DA 14/0063
Tweed City Shopping Centre

Thank you for the opportunity to meet with Belinda Hufton of DEXUS Property Group and myself on Tuesday 28th April, together with your colleagues to discuss the above application. The purpose of this letter is to provide a formal response to various matters raised during Council's assessment processes as detailed in various e-mails issued to Urbis by Council.

Attachment 1 - Applicant's Response to Submissions and Matters Raised by Council

Plan submitted by Council's Urban Designer – All issues raised in this drawing are addressed in the table above.

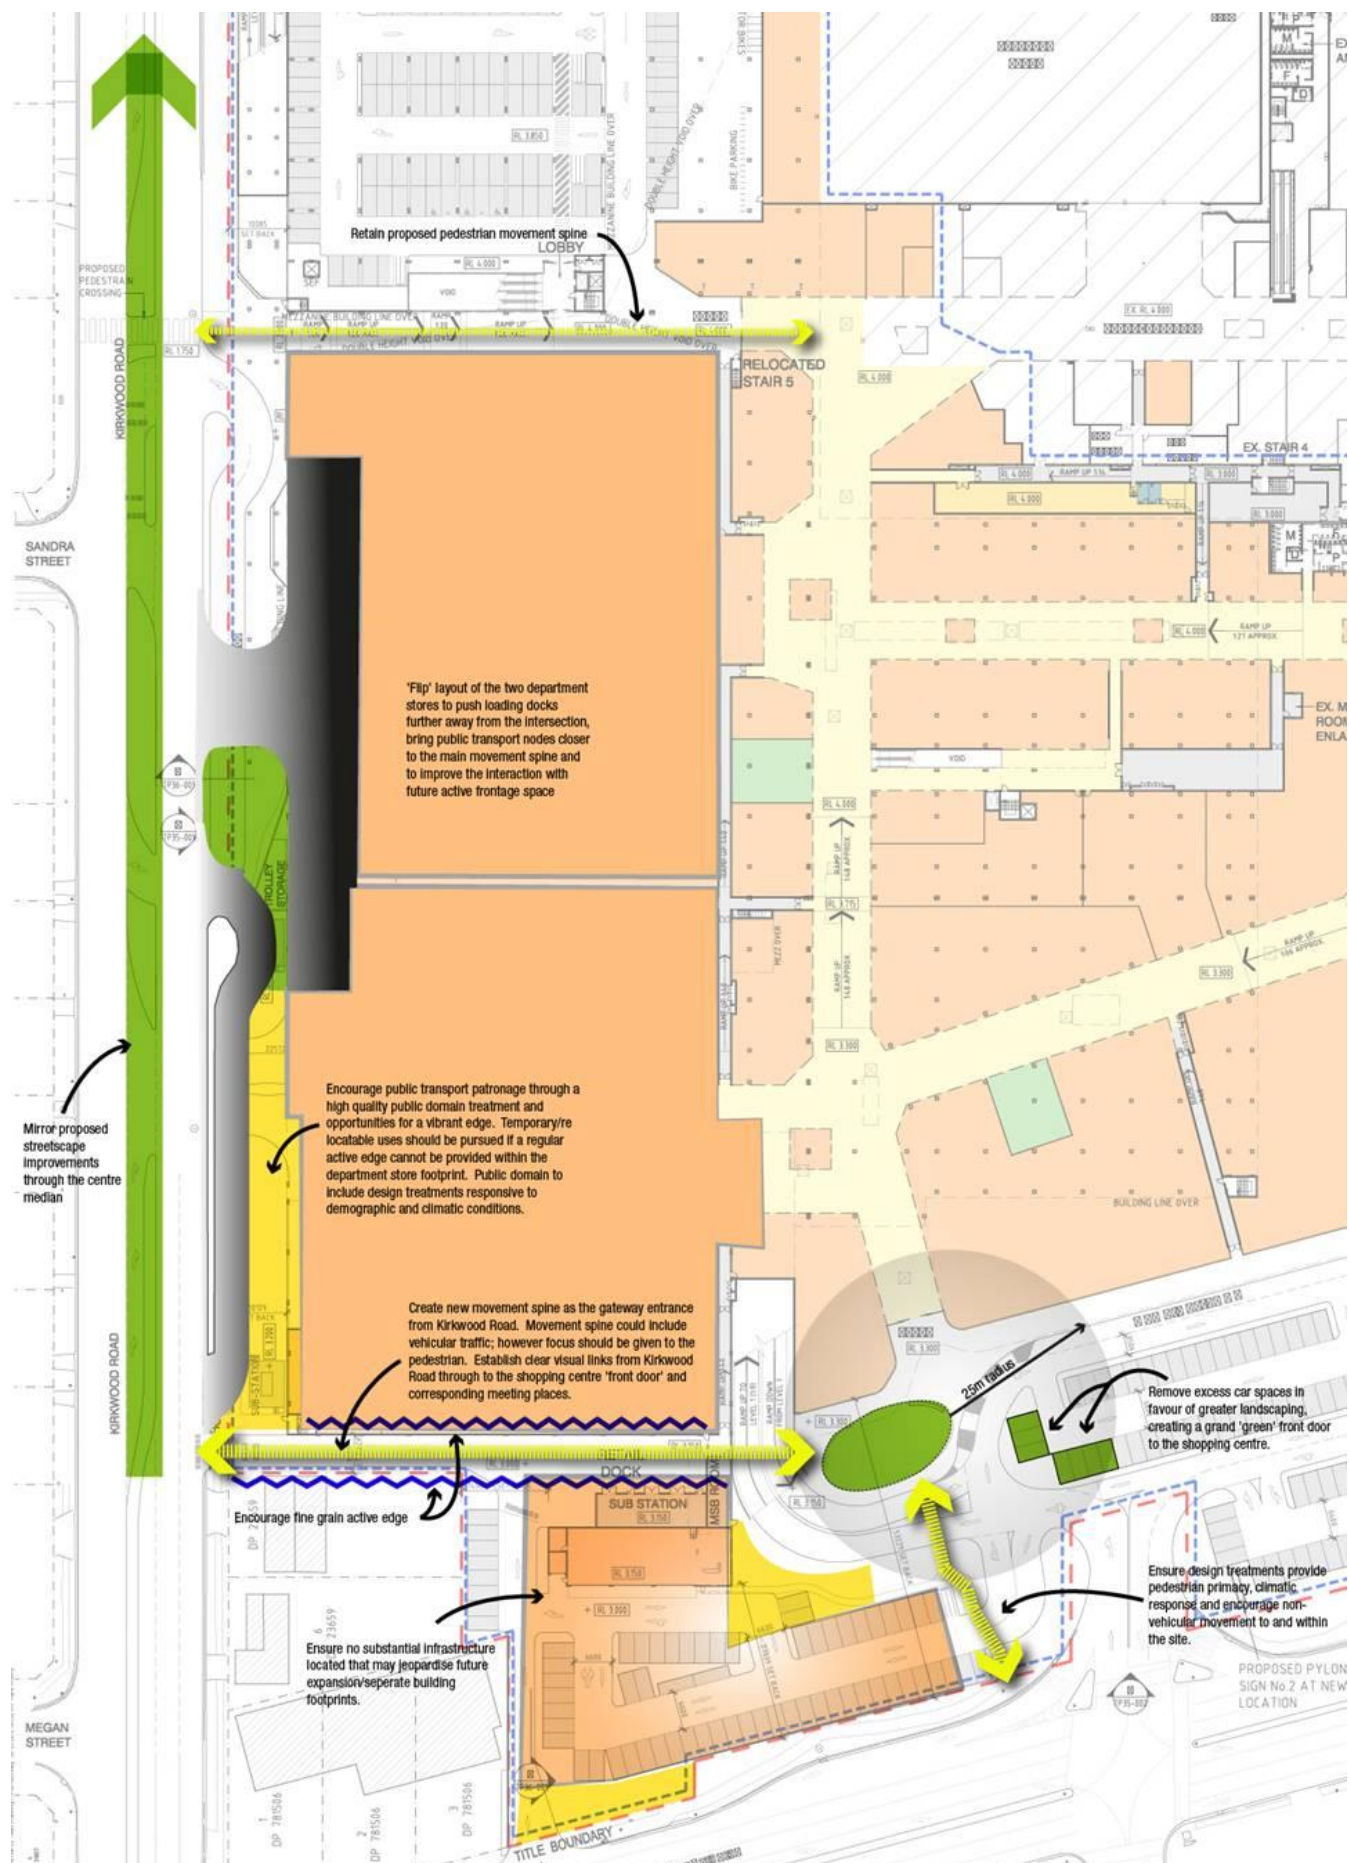
<p>1. Explore 'flipping' the location of the transport interchange and the loading docks.</p> <p>Minjungbal Drive represents the primary movement corridor external to the site and Kirkwood the secondary. Accordingly, the intersection of Minjungbal and Kirkwood will play a critical role in providing the key corner with active street frontages in the future and pedestrian activity dissipating eastward from the corner. The proposal places the loading bays immediately beside the future active street frontage, severing the ability for pedestrian activity to move eastward. Likewise, greater synergies would be anticipated by locating the transport interchange closer to the key corner and active uses, which should support both functions</p>	<p>The urban design proposal to 'flip' the loading area and bus interchange on Kirkwood Road poses significant concerns relating to traffic operations and safety. A response to this option is provided by Bitzios Consulting, which is included as an attachment to this document.</p> <p>In addition retail planning design requirements have also driven the design. The current proposal represents a considered design approach taking into consideration various opportunities, requirements and constrains within the site. Retail precincts within centres, which contain like for like shopping categories is preferred by customers. The retail design and layout has been designed with this in mind and as a result the optimal location for the two storey box is at the front of the centre.</p>

<p>6. Beautify the entrance</p> <p>There is opportunity to substantially improve the visual and user amenity of the buildings 'front door' by removing approximately seven car spaces in-trade for greater landscaping and public domain treatment. This amendment would assist in creating an attractive entry statement and simplify the visual amenity when entering the site at the Blundell Boulevard intersection, in keeping with the provisions of Section B2. The seven spaces identified are displayed within the Figure below</p>	<p>Refer to above comments.</p>

<p>8. Ensure a safe and comfortable pedestrian movement corridor from Minjungbal Drive</p> <p>The primacy of the pedestrian when moving from Minjungbal Drive, particularly the Blundell Boulevard intersection, to the buildings 'front door' should be ensured. It is noted that the proposal includes a reasonably direct pedestrian movement path, though some areas of conflict (largely unavoidable) are present. The proponent should be encouraged to consider and detail design treatments that ensure the primacy of the pedestrian in these areas of conflict, as well as support this method to transport through providing climatic comfort. By way of example, the designated pedestrian crossings could be raised crossings to reduce level differences for pedestrians and provide a greater visual cue for vehicle users to slow and stop. Likewise, landscaping or awning structures could provide shade and shelter to users and potentially include a water bubbler in light of the travel distances within the site and wider locality. Finally, the pedestrian pathways could also be</p>	<p>Raised pedestrian crossing points and wider pedestrian crossings can be provided between the centre entry and Minjungbal Drive frontage to reduce traffic conflict.</p>

Figure 1: Water level contours show a general westerly groundwater flow direction

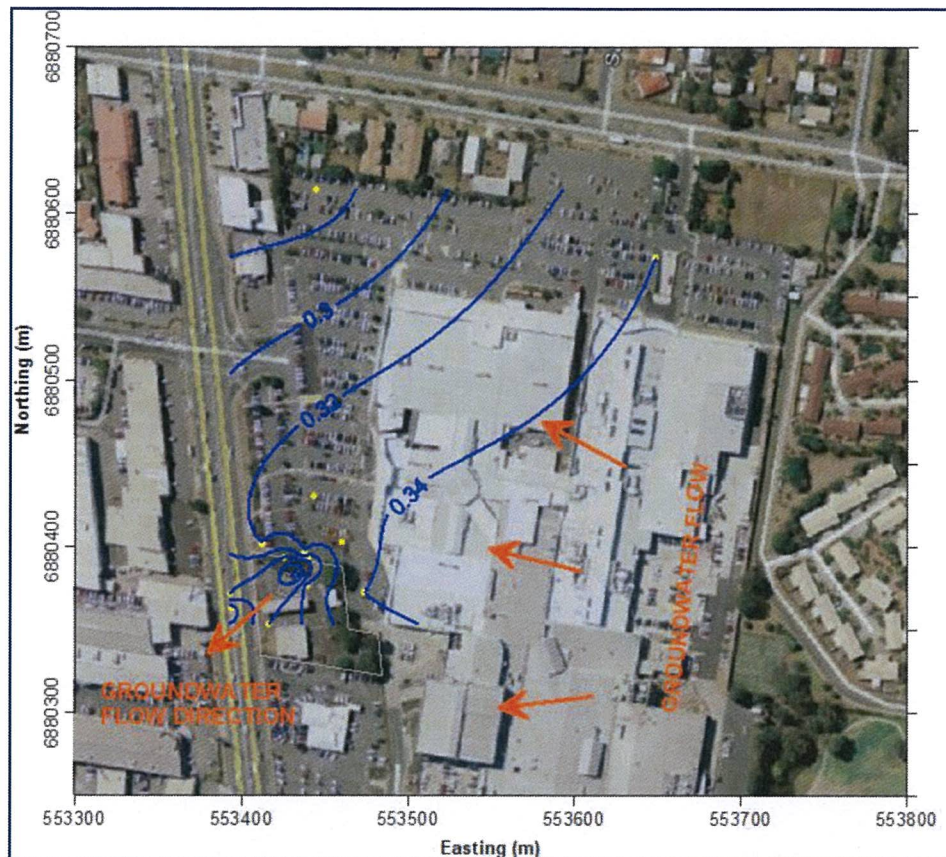
Item 7: *The Roadworks and Drainage Layout plan SKC100 provided under the Civil Engineering Report, Bornhorst and Ward November 2013 indicates one of the Humeceptor STC9 devices to be located in near proximity to the former service station – dewatering is required for placement of these devices (approximately 1.4m deep from information in the Civil Engineering Report). The applicant is requested to comment further on the possibility of draw down or extraction of contaminated groundwater from the former service station site.*

As shown in Figure 1 below, groundwater flow in this area is in a direction away from the shopping centre site. Dewatering to install the Humeceptor would occur over a short period of time (less than one day) and would not change the groundwater flow direction. However, it is acknowledged that it would create localised drawdown effects. It is intended that the water generated by this dewatering, would be captured, contained and removed from site in a tanker operated by a licensed liquid waste removalist in case any contaminated or odorous water is generated.
